G73-07/08

404.1.1

Proponent: Sarah A. Rice, CBO, Schirmer Engineering Corporation

Revise definition as follows:

Figure 1. Bumper Load Application

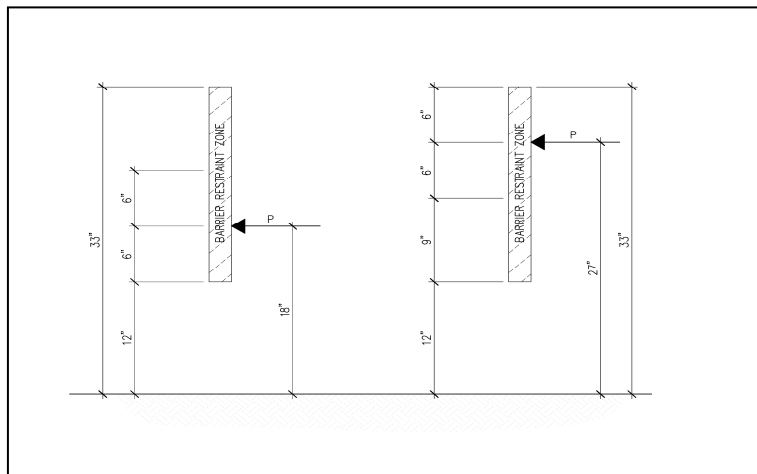
It should be noted that the act of a bumper wall resisting a vehicle striking it is truly a dynamic energy problem—not a static load problem. However, building codes at that time used percentages of static loads to allow for the impact effects on structures. Thus, the use of the 10,000 pound ultimate horizontal static load was deemed appropriate for a 5,000-pound vehicle traveling at a speed of 5 mph.

Therefore, in 1980, the PCC Code Committee developed the following for the design of barrier restraints, "*Barrier railings should be placed at the ends of drive lanes and at the ends of parking spaces at the perimeter of the structure and at the end of parking spaces where the difference in floor elevation is greater than one foot. Barrier railings should be not less than two feet in height and should be designed for a minimum horizontal ultimate load of 10,000 pounds applied at a height of one foot six inches above the floor at any point along the structure.*" A footnote stated, "*It is the intent that the horizontal load be considered as applied over a one-foot square area with the load distributed through the barrier railing system into the main structural elements in a manner which is logical and appropriate for the barrier railing system under consideration.*"

The PCC barrier rail recommendation was first adopted by the ICBO in the 1990 UBC Supplement. Many multistory parking structures designed prior to 1990 did not meet this requirement. Similar language was incorporated into a number of the model building codes with, in some cases, the load being changed from a 10,000 pound ultimate load to a 6,000 pound service load. The 6000 pound service load with the proper load factor is approximately the same as the 10,000 pound ultimate or factored load.

1607.7.3 Vehicle barriers. Vehicle barrier systems for passenger cars shall be designed to resist a single load of 6,000 pounds (26.70 kN) applied horizontally in any direction to the barrier system and shall have anchorage or attachment capable of transmitting this load to the structure. For design of the system, two loading conditions shall be analyzed. The first condition shall apply the load shall be assumed to act at a minimum height of 1 foot, 6 inches (457 mm) above the floor or ramp surface. The second loading condition shall apply the load at 2 feet, 3 inches (686 mm) above the floor or ramp surface. The more severe load condition shall govern the design of the barrier restraint system. The load shall be assumed to act on an area not to exceed 1 square foot (305 mm²), and is not required to be assumed to act concurrently with any handrail or guard loadings specified in the preceding paragraphs of Section 1607.7.1. Garages accommodating trucks and buses shall be designed in accordance with an approved method that contains provision for traffic railings

**FIGURE 1 – 408.5.3 Item 3
MULTILEVEL RESIDENTIAL HOUSING WITHOUT
VERTICAL OPENING ENCLOSURE**

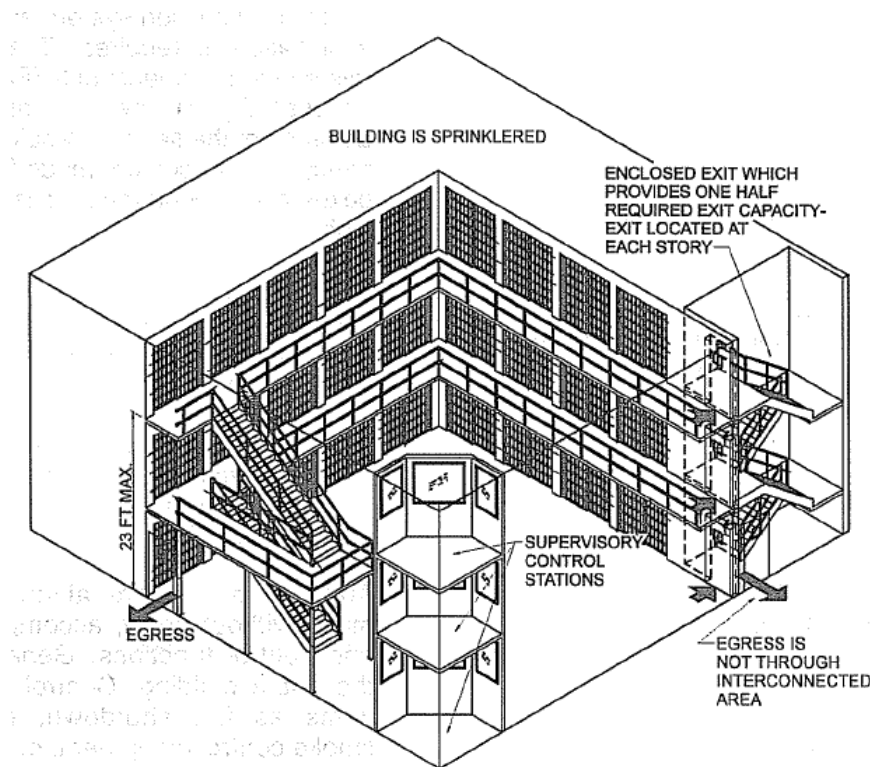
Reason: This change is intended to clarify the exiting from floor levels within the residential housing units. Without this change the "floor levels" get treated as stories and additional exits are required. Currently a residential housing unit with two floor levels and a very small occupant load can be required to have three exits which in a detention facility is problematic. This change would then allow the two level units to have just two exits with no direct egress from the upper floor level as long as common path and travel distances are met. The figures below illustrate the proposal and should be included in the commentary.

408.5.3 Floor openings. A floor opening between floor levels of residential housing areas is permitted without enclosure protection between the levels, provided the following conditions are met:

1. The entire normally occupied areas so interconnected are open and unobstructed so as to enable observation of the areas by supervisory personnel.
2. Means of egress capacity is sufficient to provide simultaneous egress for all occupants from all interconnected levels and areas.
3. The height difference between the highest and lowest finished floor levels shall not exceed 23 feet (7010 mm). Each floor level, considered separately, shall have at least one-half of the required means of egress capacity provided by exits leading directly out of that floor level without traversing another floor level within the interconnected area.

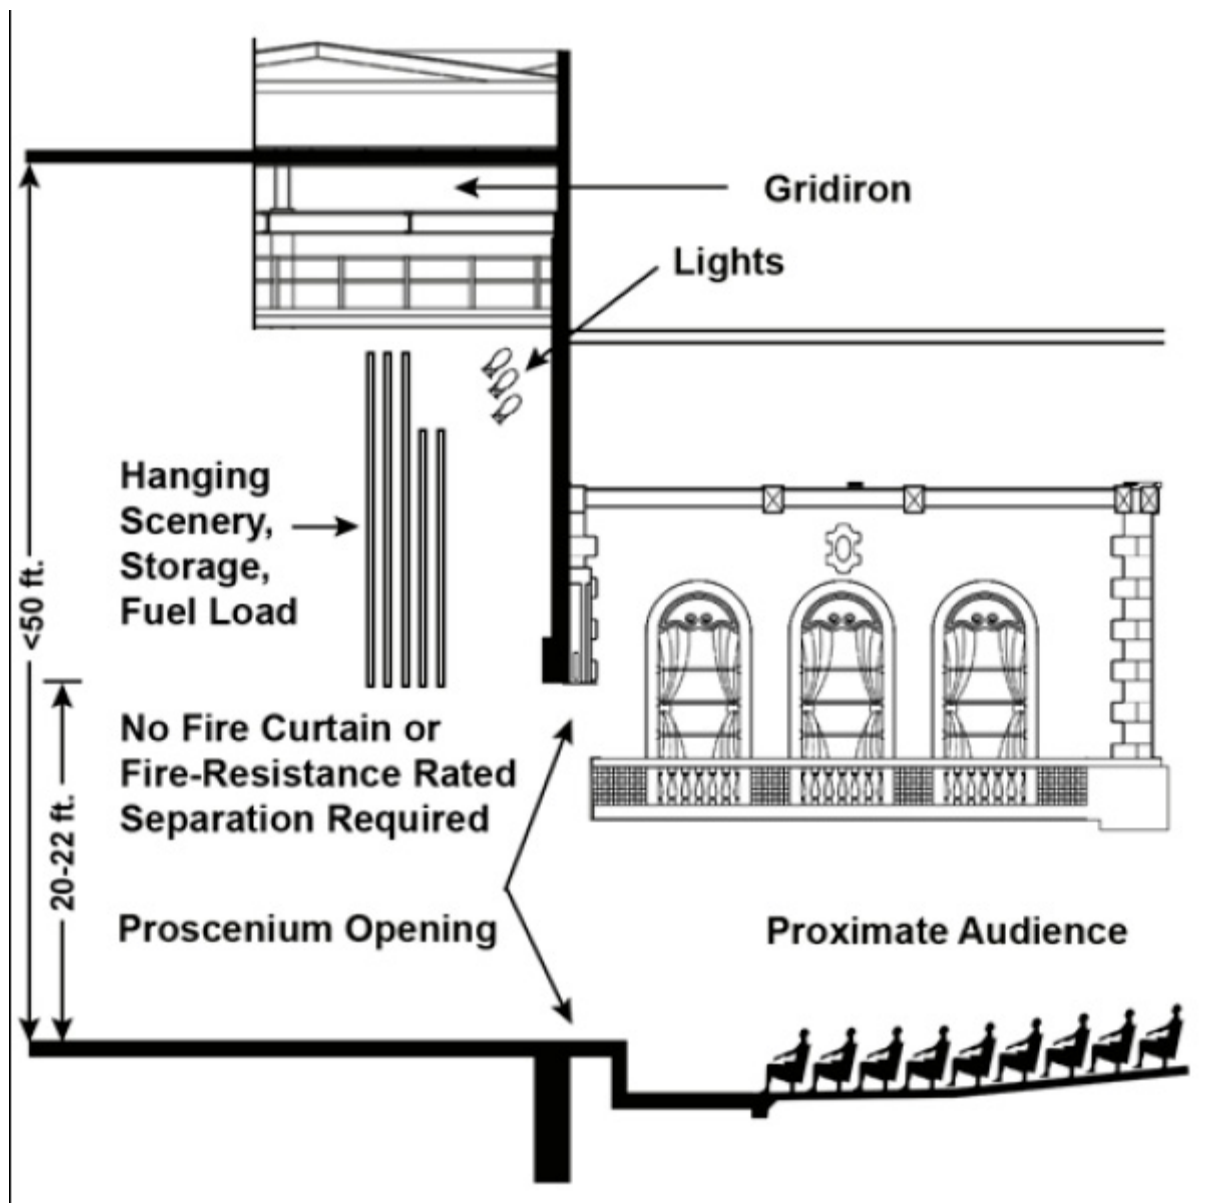
Reason: The change lowers the proscenium-opening threshold where a fire barrier between the audience and the stage must be constructed. This will also become the threshold at which a fabric fire curtain or deluge water spray system is also installed in the proscenium opening.

Legitimate stages of heights greater than 45 feet have the ability to store flying scenery and other stage effects that can add significantly to stage fuel loads.

Existing <50 foot stage height allows for combustible storage above the stage and no fire curtain.

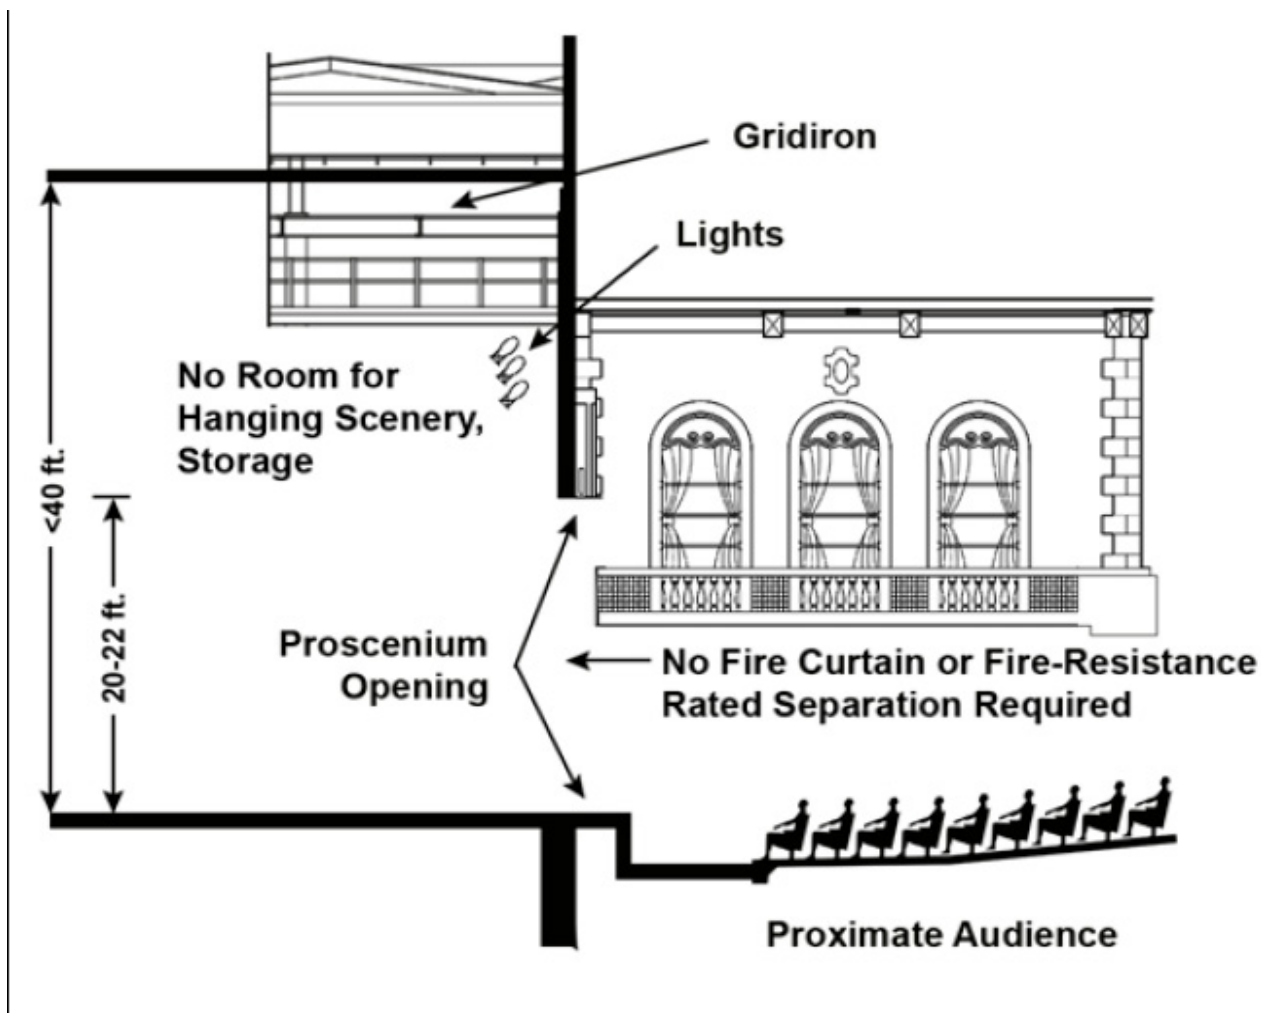
The last two code cycles have seen proposals which have attempted to be all-encompassing, addressing all types of stages to narrow the scope of height changes and various methods to determine the fuel load threshold at which a proscenium wall and proscenium opening protection must be provided. The committee found fault in an expanded scope that attempted to define all types of stages and did not accept that a fuel load basis could be used for new construction. This proposal lowers the current 50-foot limit to 40 feet where significant storage begins to occur.

Proposed 40 foot minimum does not allow for combustible storage & no fire curtain is required.
